Mottagare: Kontrollanter, kontrollantelever, klubbar	Datum: 2021-09-22	Bilaga Firebird PSB FB 2021-01	Blad nr: 1 av 1
Fastställt av MK: 2021-09-22		Ersätter:	Ärende: Materielvarning nr. 2021/2
		Utfärdare: SFF Materielkommitté (MK)

PRODUCT SERVICE BULLETIN

Bulletin Number: FB 2021-01

SUBJECT: Firebird V1R1 EVO Harness container systems with adjustable Main Lift Web

DAMAGES

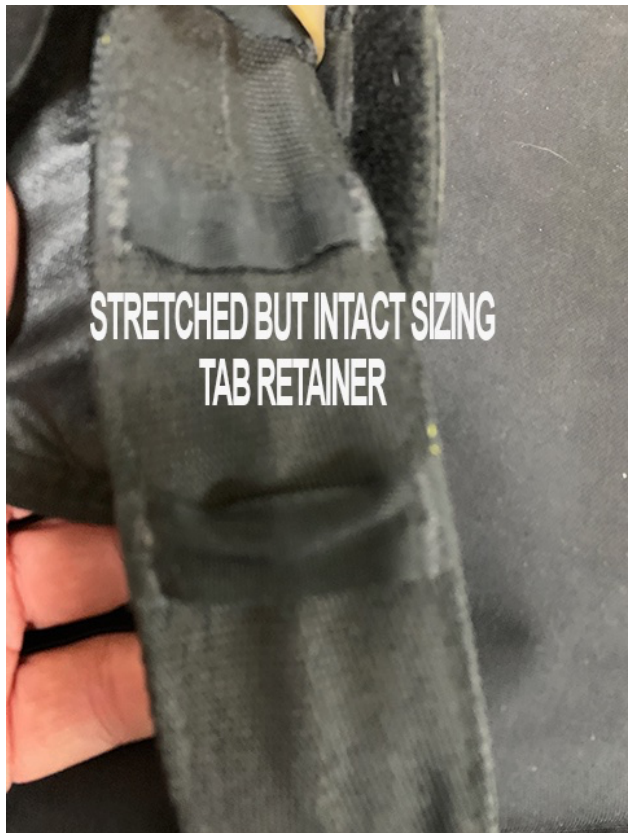
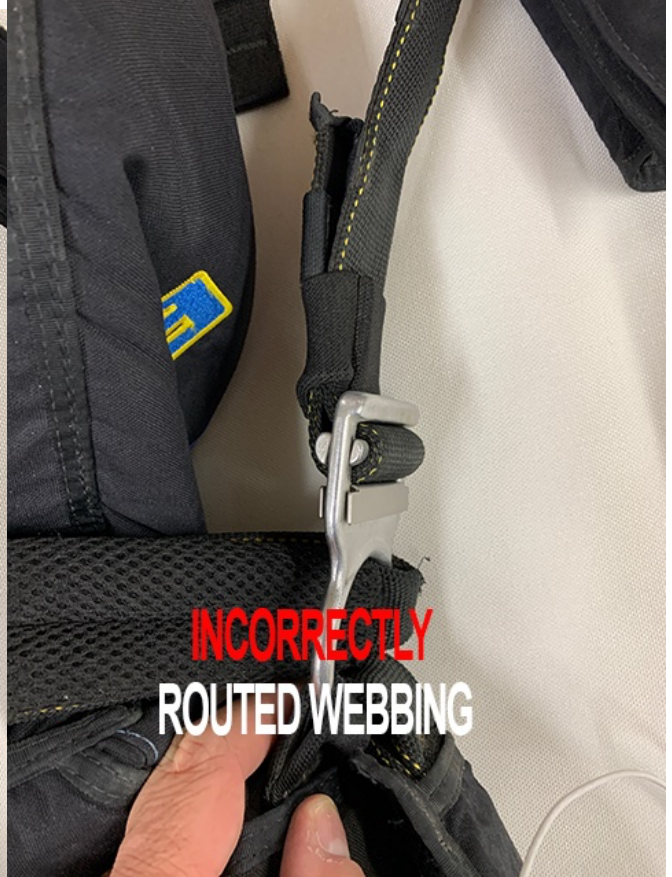
Right Main lift web undone, sizing safety tab ripped off and stuck under a stretched but intact sizing tab retainer (1/2" type 1), 555-2 ring installed **correctly**, **missing** spring, **NO** damage to type 4 stopper.

Left Main lift web threaded **incorrectly** (double routing, wrong direction, see pics), sizing safety tab attached with only a few stitches (69tex/E thread) ripped, sizing tab retainer stretched but intact, 552-2 ring installed **correctly**, spring present, **NO** damage to type 4 stopper.

Stretched tab retainer

Torn off tab, damage free type 4

Therefore, we mandate a visually inspection before the next jump, to confirm the correct routing of the adjustable main lift web through a type 555-2 ring (DJA/CWH) especially if the container has been disassembled for repairs, maintenance, cleaning, or any other reason. All direct customers have been contacted by Firebird USA LLC.

To make sure that in the future only qualified Riggers can disassemble the main lift web, we strongly recommend replacing the type 4 stopper with four layers of type 17 webbing and sew a BOX X pattern with at least 5-cord. Firebird USA LLC uses exclusively 6-cord.
